DEVELOPMENT REVIEW BOARD  
**SUPPLEMENTAL SUBMITTAL**

**Project Location: Whataburger – Volcano Rd. & 98<sup>th</sup> St.**  
**DRB Project Number: PR-2019-002402**

Bowman Consulting is in receipt of the comments dated March 16, 2022, issued by City of Albuquerque for the Whataburger restaurant at NEC of Volcano Rd. & 98<sup>th</sup> St, Albuquerque, NM 87121. Please see below for the responses to the comments:

**SITE PLAN**  
**WHATABURGER**  
**NEC 98TH ST. & VOLCANO RD.**  
 ALBUQUERQUE, NM 87124

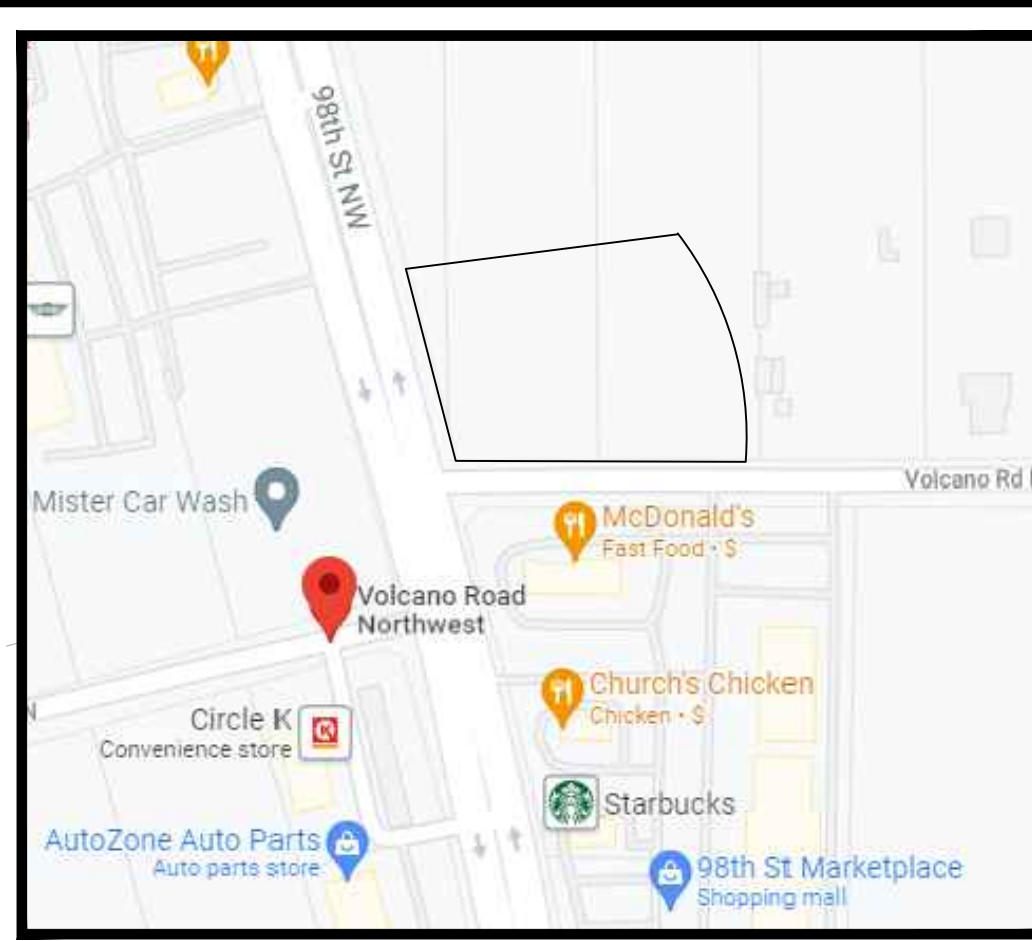
- Comment 1:** Add a bold note that the accessways surrounding site and public roadway improvements shall be built per work order. The accessway shall be in place prior to Certificate of Occupancy.

**Response: Note has been added.**
- Comment 2:** For the one-way aisle within the drive-thru directional arrows on the pavement for the site plan. Also, add a One-way sign.

**Response: One-way aisle drive-thru directional arrows and one-way signs have been added see key note 2D.**
- Comment 3:** For the handicapped ramp at the accessible aisle, ensure that there is a minimum 4-foot dimension between the wing of the ramp and the corner of the building. (Add a dimension at the pinch point around the main entrance.)

**Response: Minimum 4ft. dimensions have been labeled to show clearance between building corner and ramp.**
- Comment 4:** Indicate a maximum 2% cross-slope on the sidewalk detail. Also, on the site plan, indicate which type of curb shall be used.

**Response: 2% cross-slope minimum labels have been added to sidewalk detail and site plan. Curb type has been labeled; see key notes.**
- Comment 5:** On 98th Street and Volcano, use a clear sight triangle for intersection sight distance to be sure that there are no conflicts with the proposed landscaping. Add the note "Landscaping, fencing and signing will not interfere with clear sight requirements. Therefore, signs, walls, trees, and shrubbery between 3 and 8 feet tall (as measured from the gutter pan) will not be acceptable in the clear sight triangle."

**Comment 6:** Dimension the parking aisle south of the building at different locations where the width varies, and also include a dimension at the entranceway. Also, dimension the 6-foot ADA pathway to Volcano Road.

**Response: Sight distance triangles have been added to the site plan and landscape plan to confirm no landscaping, fencing and signage interfere with visibility.**

**Response: Parking aisle, entranceway and ADA pathway dimensions have been labeled.**

ALL ACCESS WAYS SURROUNDING SITE AND PUBLIC ROADWAY IMPROVEMENTS SHALL BE BUILT PER WORK ORDER. THE ACCESS WAY SHALL BE IN PLACE PRIOR TO CERTIFICATE OF OCCUPANCY.
